Harnett County Government Complex  
307 W. Cornelius Harnett Boulevard  
Lillington, NC 27546

115 BWS

**Re: Status of Improvement Permit Application: SFDS2107-0043**

CUMBERLAND HOMES, INC.  
 THE TIFFANY  
 LOT # 115 BALLARD WOODS  
 SCALE: 1"=40'

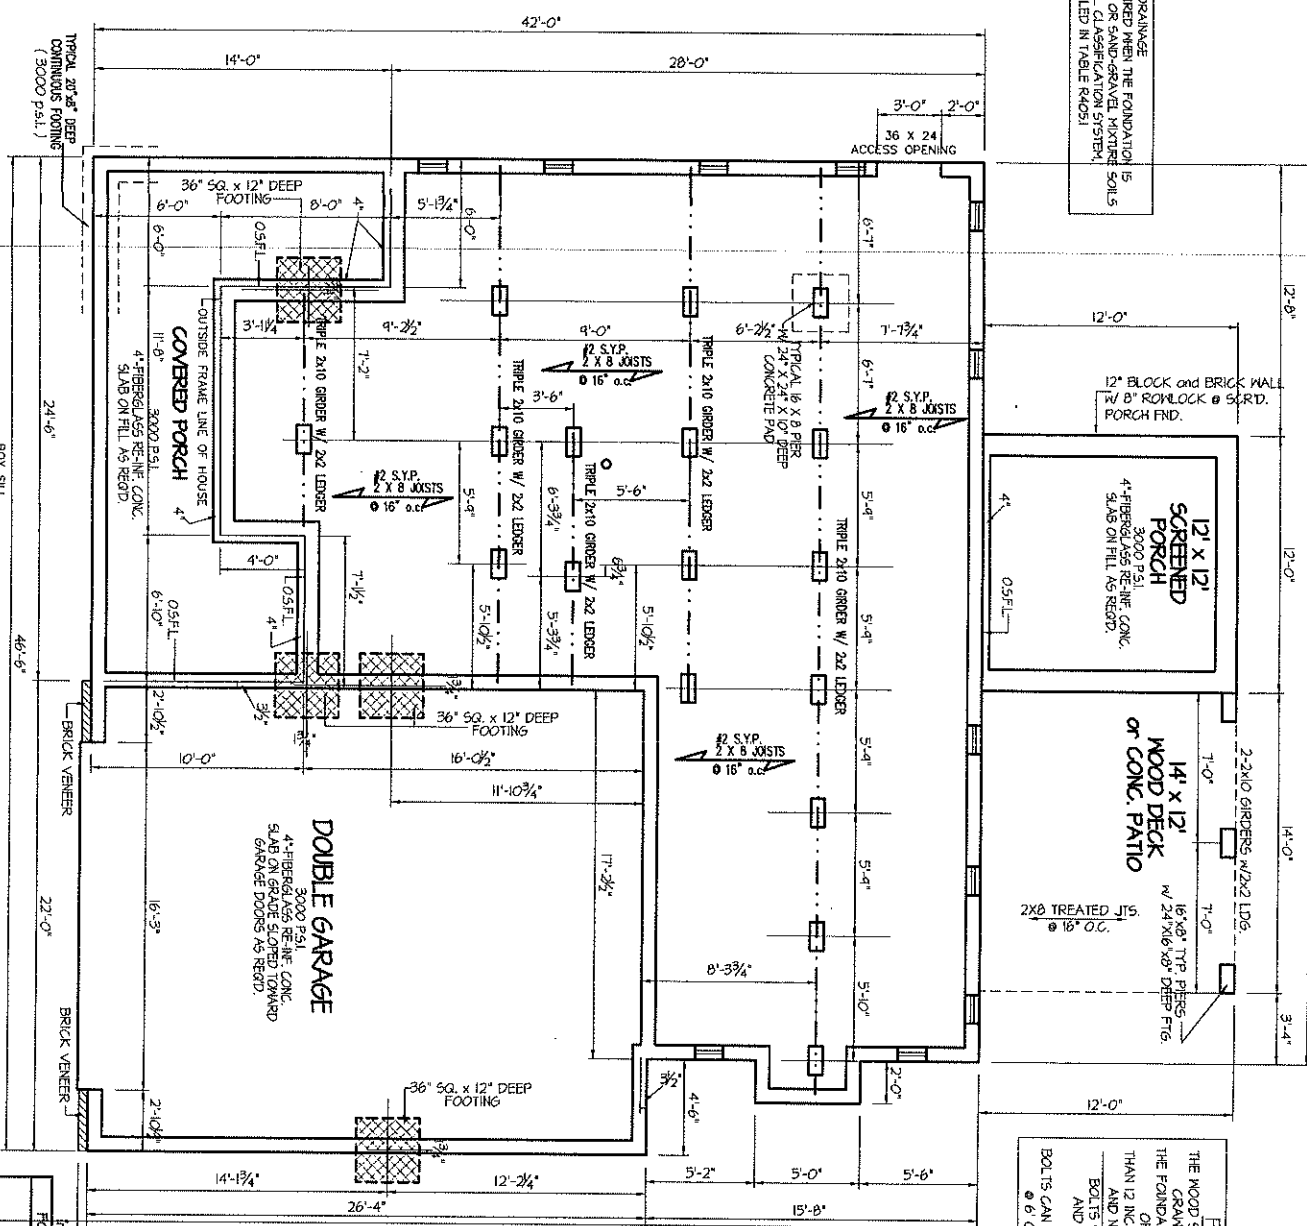
- 1. Use pink flags to mark property lines and irons that are set by surveyor need to be visible. (\$25.00 fee incurred)
- 2. Use orange flags to mark house corners (\$25.00 fee incurred)
- 3. Directions not clear to property (\$25.00 fee incurred)
- 4. Property needs only brush or vegetation removed
- 5. Driveway not shown on site plan
- 6. Backhoe pits required
- 7. **Other- Soil Scientist Proposal required – Shallow unsuitable soils present on front of lot and unsuitable wet soil and topography on back portion of property. Soil Scientist proposal and layout required with application.**

**Additional requirements: Due to property line lengths into woods. Side property lines shall be cleared to allow a line of site and/or line shall be marked/staked by a surveyor. Pre-existing retention pond was onsite. Edge of disturbed area shall be marked onsite and documented accordingly. Retention pond was placed in area of limited soil availability.**
